In the Matter of)
) Docket Nos. 50-237-SP
COMMONWEALTH EDISON COMPANY) 50-249-SP ✓
) (Spent Fuel Pool
(Dresden Station, Units 2 & 3) Modification)

LICENSING REPORT
DRESDEN NUCLEAR POWER PLANT
UNITS 2 AND 3
SPENT FUEL RACK MODIFICATION

DOCUMENT #: QUAD-1-79-234

REVISION SHEET

FIGURE 3.6-9: DRESDEN UNITS NO. 2 & 3
SPENT FUEL POOL MODEL
FOR NATURAL CIRCULATION

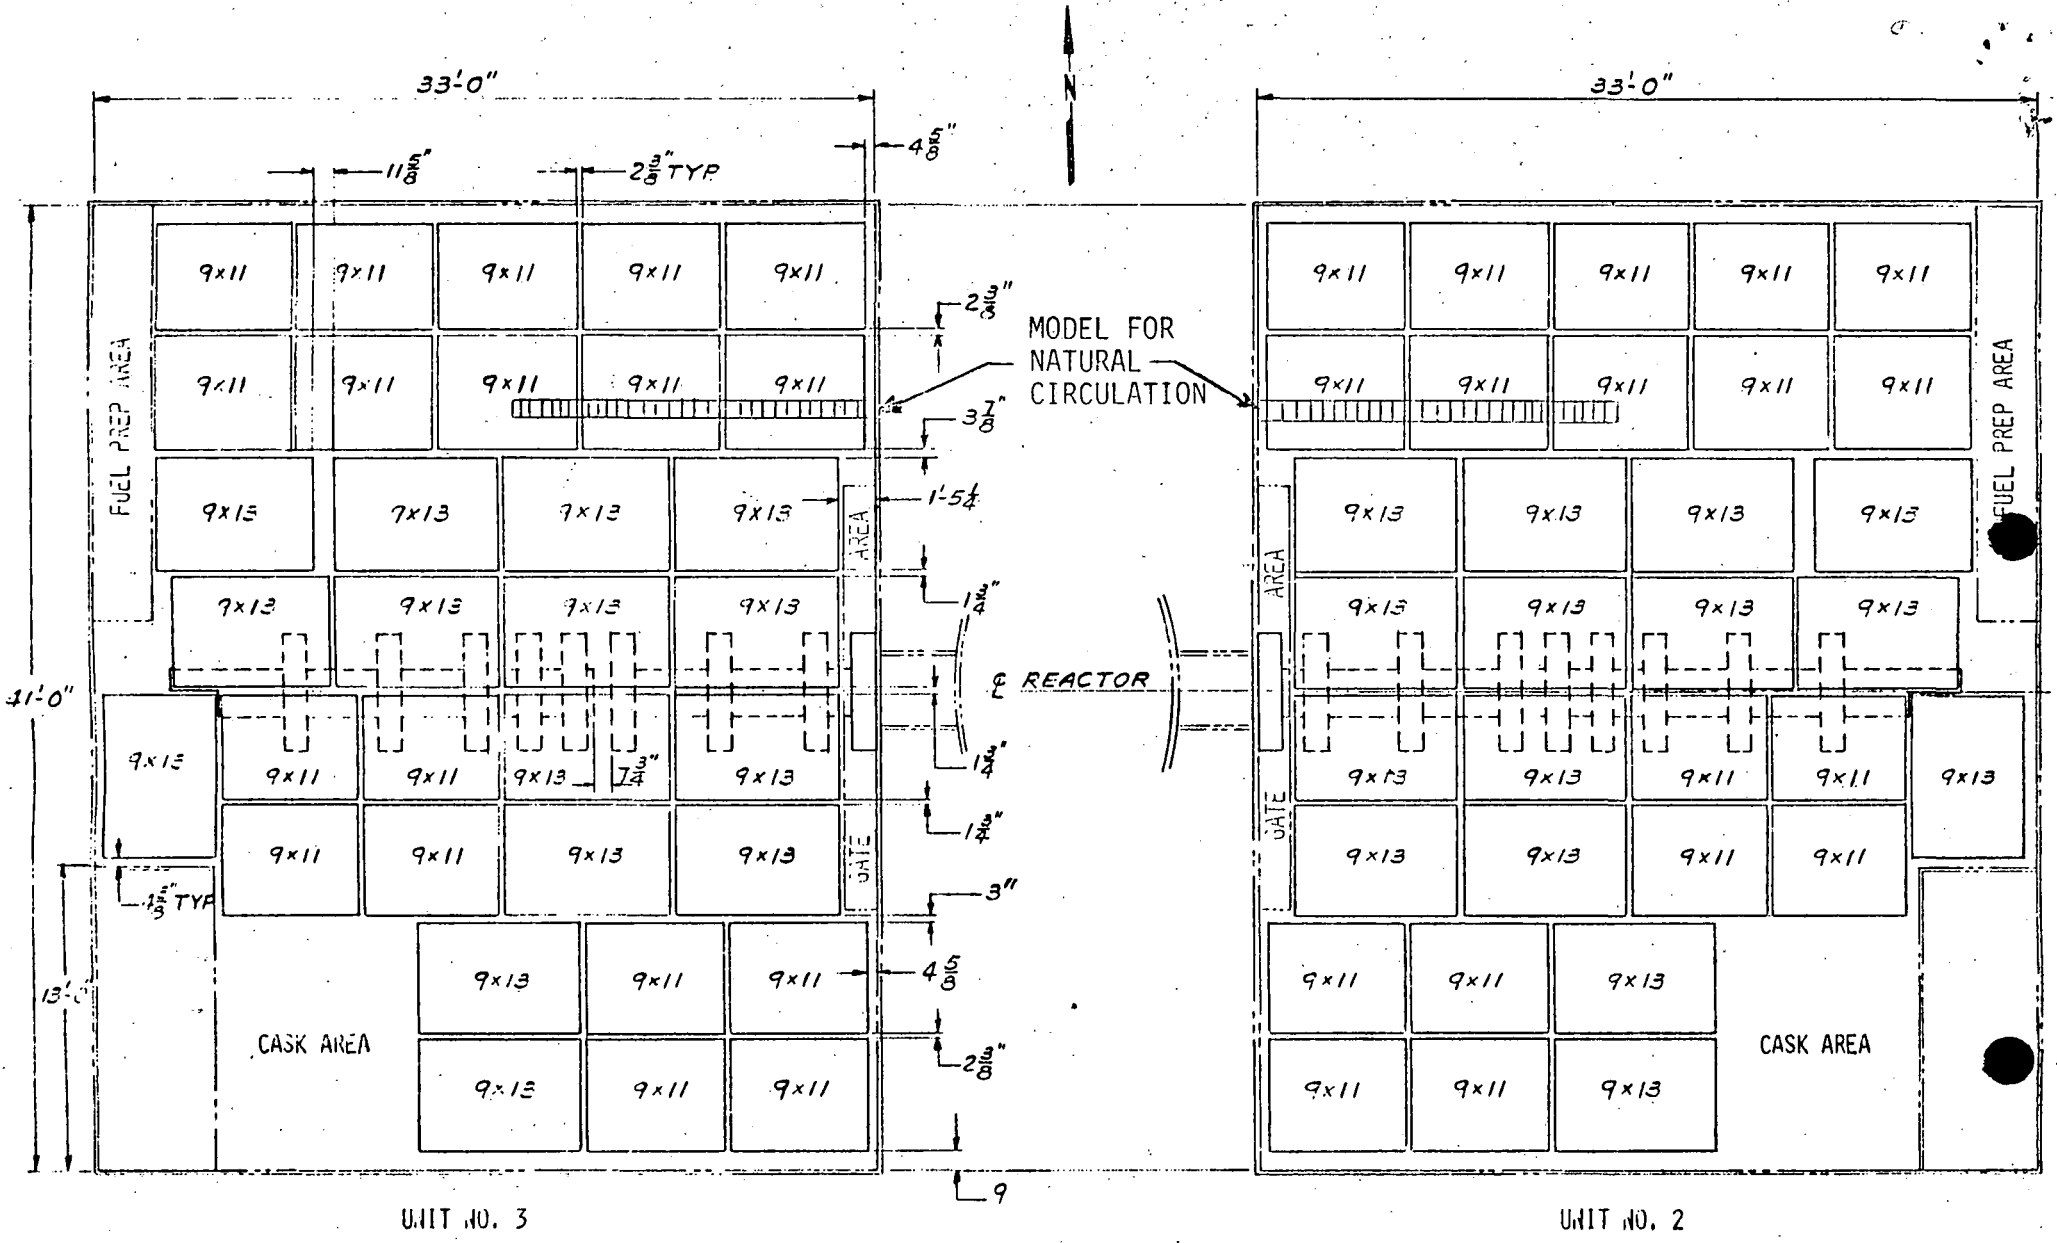
12.	Figure 3.6-8 - Number of flow channels changed from 30 to 28.	3-64
13.	Figure 3.6-9 - Revised fuel storage pool arrangement.	3-65
